Tesla, Inc. Service Bulletin		<i>Install Ferrite Cores onto Ancillary Bay Harness</i>	
SB-23-16-008 December 16, 2023					
Classification		Section/Group		Mobile Service	Configuration
Repair Bulletin		16 - HV Battery System		Cannot Perform	LHD Structural Pack
Model Year	Model	Country/Region		Build Location	
2023	Model Y	Europe		Giga Berlin	
The model(s) and model year(s) listed are a general approximation of the affected VIN list. Refer to the VIN/Bulletin Tracker or Customer/Vehicle profile to determine applicability of this bulletin for a particular vehicle.

Figure 1

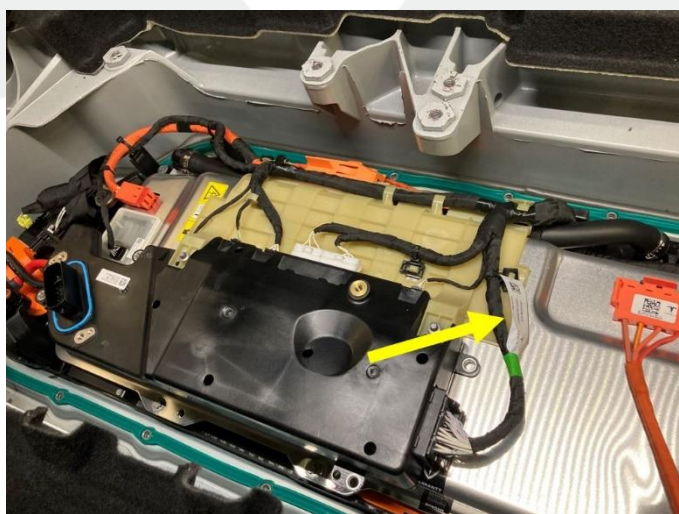
3. Confirm the ancillary bay LV harness part number.

NOTE: The part number label is located on top of the PCS, next to HVC connector (Figure 1).

- If the part number is 1616706-00-F or later, go to step 21.
 - If the part number is 1616706-00-E or earlier, go to the next step.
4. Verify that the HV insulator covers are present (Figure 2).

Figure 3

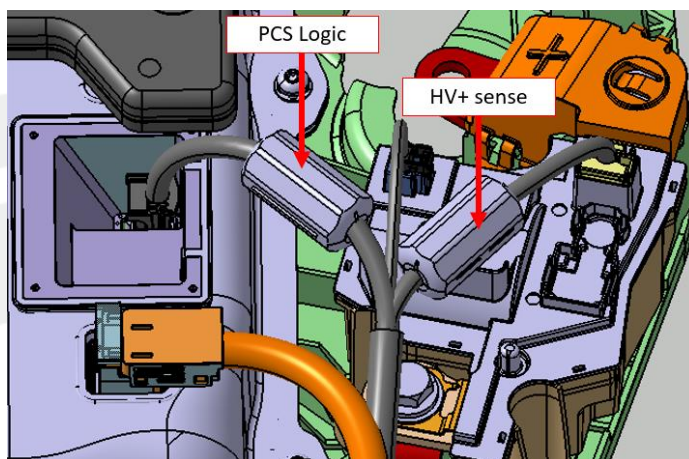
6. If clip-on ferrites are present on this section of the ancillary bay LV harness, remove and discard the ferrites from the PCS logic harness branch and the HV+ sense harness branch (Figure 3).

📋 NOTE: The clip-on ferrites are covered in tape. If the tape on the harness is damaged or removed, apply new tape to the PCS logic harness branch. The tape on the HV+ sense harness branch will be removed in a later step.
